York Civic Trust's response to the City of York Council's Railway Station Front Consultation, June – July 2018

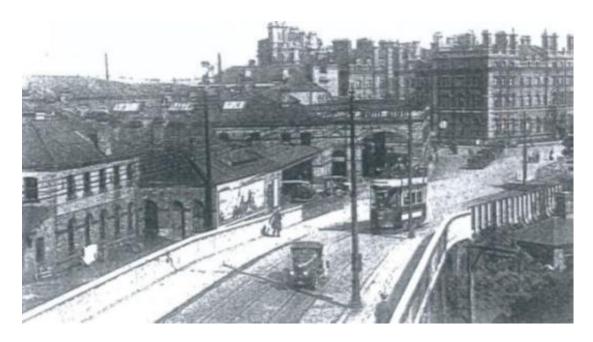
The area named Station Square or Parcel's Square in the proposals appears to relate to the area currently occupied by the former Parcels Office and Traincrew accommodation. Both these buildings are in effect replacement buildings following the bomb damage sustained in the Baedeker raid of 29 April 1942. The attached photograph shows the buildings prior to the raid.
